FISH STREAM SURVEY

DATE: MAY 20, 1980

STREAM CATALOGUE # 103-90-084 (ROAD) 5645 (NORTH)

5645 (NORTH)
Marble Island
20 May 1980

5645 NORTH
20 MAY 1980
MARBLE ISLAND

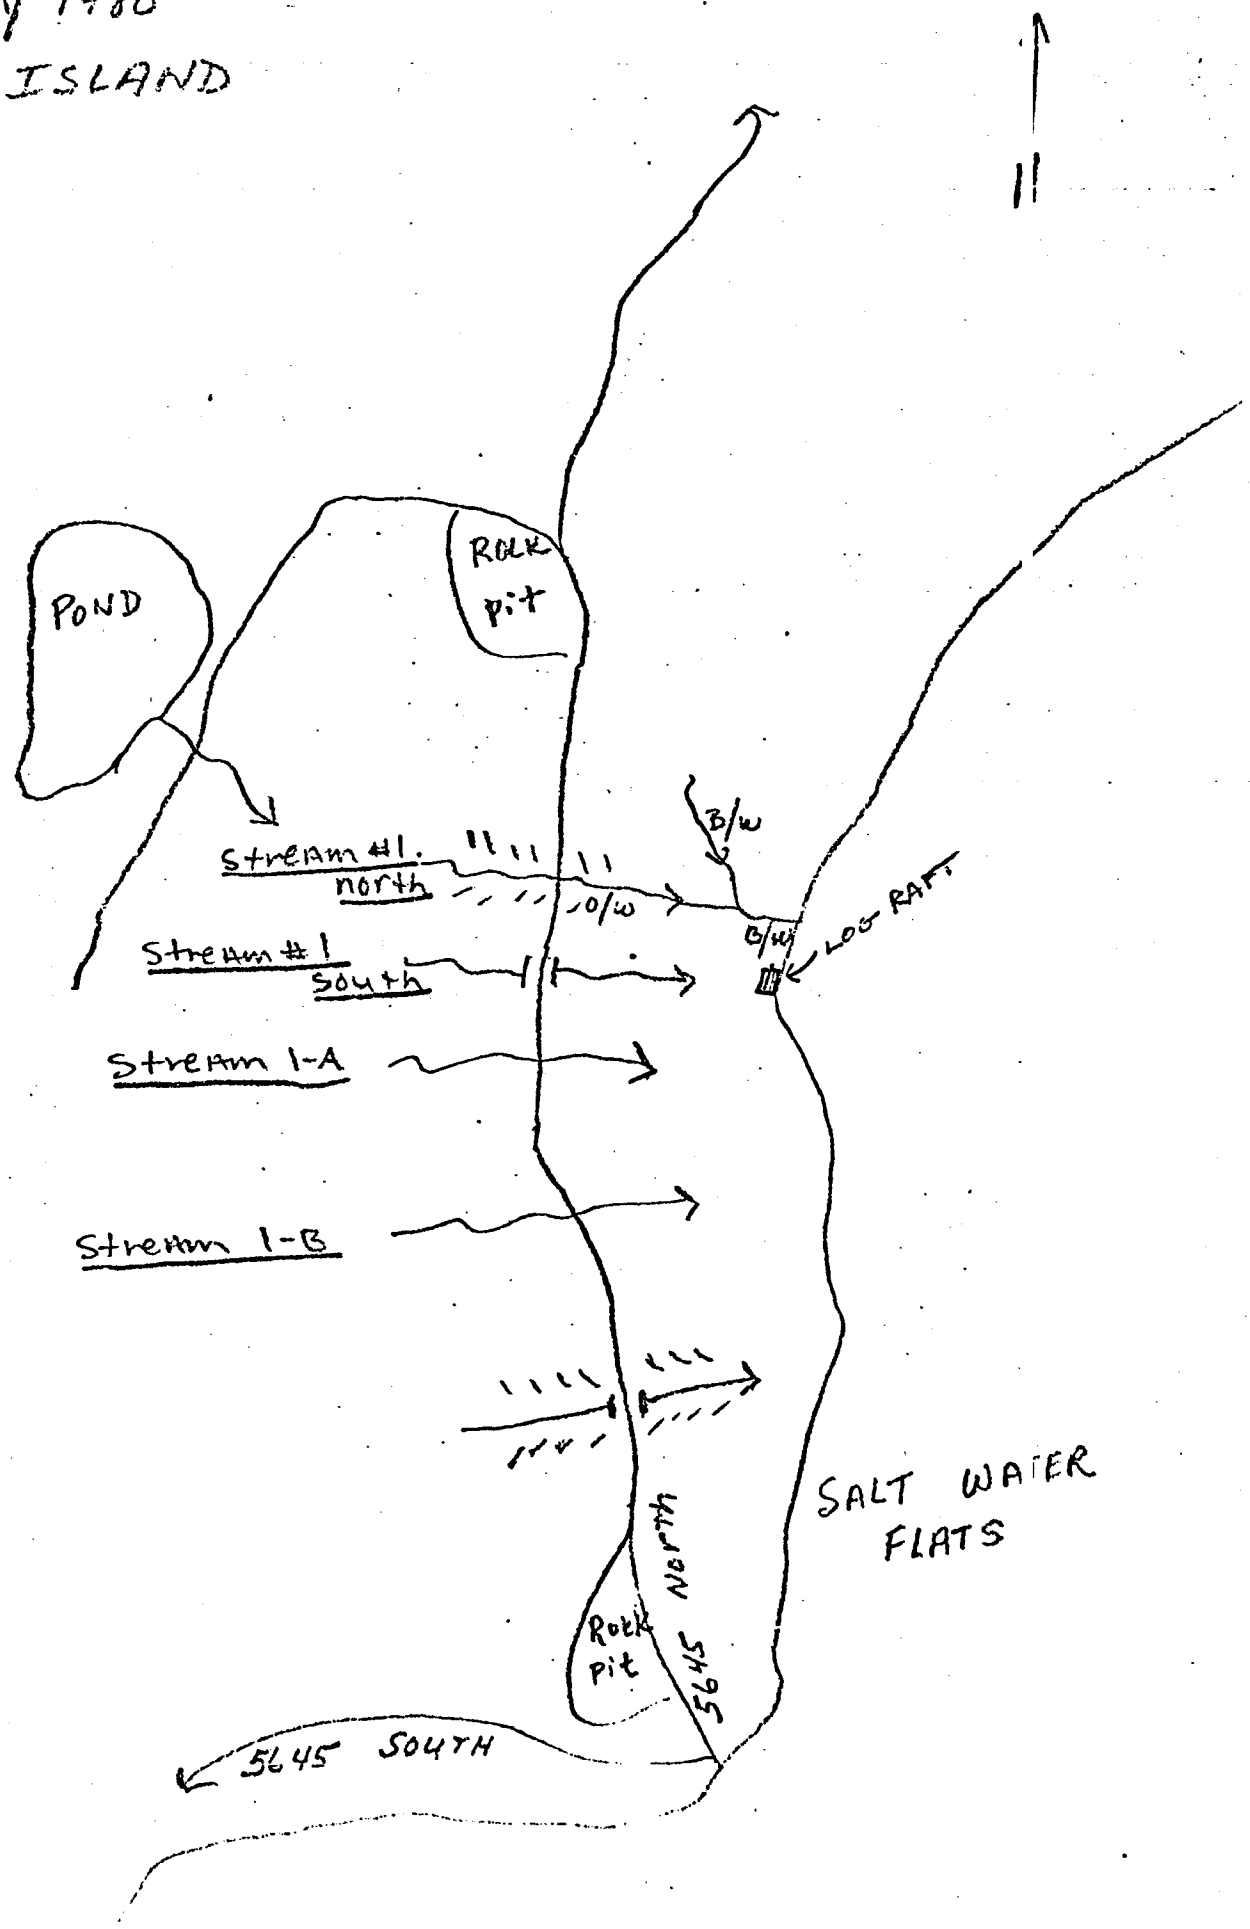
The bridge over this V-notch looks good and the stream was cleaned out. Recommend that old batteries not be discarded along the road so as to maintain water quality.

This culvert passes fish OK and was chunk cleaned OK.

This culvert passes fish OK and was chunk cleaned OK.

There was one heavy equipment crossing upstream from the bridge. This bridge passes fish OK.

This V-notch was filled with fill and the culvert passes some water with the rest filtering through the land gravel. There is salmon habitat below the crossing but not above the crossing. There was evidence of silt 3-500' downstream. 30 coho and 10 chum salmon about 2" long were stranded downstream. Culverts should be laid to grade to avoid flow thru Road bed - Water Quality must be maintained on all fish habitat

Pond Is there ANY WAY to stop downstream sedimentation short of culvert replacement

There was no culvert were the road crosses the outlet of the pond. This pond does not contain fish. No fish passage required but a culvert should be installed.

At the mouth of these streams a float log raft is anchored. This should be removed as it is ~~situated~~ on intertidal spawning gravels.
